Access Compliance Report Public Rights-of-Way (Curb Ramps)

Intersection ID: 15174 Main Street: DILWORTH_RD_WEST Cross Street: IDEAL_WY Location: SW

ADA ID: 03EE4D6AB4C0 Ramp Type: Perp Initial Pass/Fail: Fail Overall Compliance: No Severity Score: 13.75

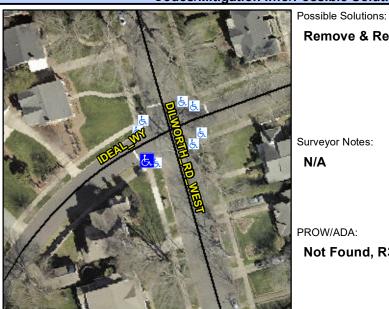
PROW/ADA:
Not Found, R304.2.2, R304.5.3

Field Measurements/Component Compliance					
Com	oliance Description	Data	Comp	liance Description	Data
N/A	Ramp Length (in)	81.0	No	Ramp Slope (%)	8.9
Yes	Ramp Width (in)	72.0	No	Ramp XSlope (%)	4.0
N/A	Flare Type LT	N/A	N/A	Flare Type RT	N/A
N/A	Flare Slope LT (%)	N/A	N/A	Flare Slope RT (%)	N/A
N/A	Flare Traversable LT?	N/A	N/A	Flare Traversable RT?	N/A
N/A	Landing Length (in)	N/A	N/A	DWS Provided?	N/A
N/A	Landing Width (in)	N/A	N/A	DWS Contrast?	N/A
N/A	Landing Slope (%)	N/A	N/A	DWS Length (in)	N/A
N/A	Landing X Slope (%)	N/A	N/A	DWS Full Width?	N/A
N/A	Landing Curb? (Y/N)	N/A	N/A	DWS Offset (in)	N/A
N/A	Shared Landing?	N/A			
N/A	Gutter Ponding?	N/A	N/A	Gutter Slope (%)	N/A
N/A	Gutter Lip Ht (in)	N/A	N/A	Gutter X Slope (%)	N/A
N/A	Painted X Walk1?	No	N/A	Painted X Walk2?	N/A
	X Walk 1 Direction	To N		X Walk 2 Direction	N/A
N/A	X Walk 1 Width (in)	N/A	N/A	X Walk 2 Width (in)	N/A
	X Walk 1 Slope (%)	5.1		X Walk 2 Slope (%)	N/A

Remove & Replace Entire Ramp.
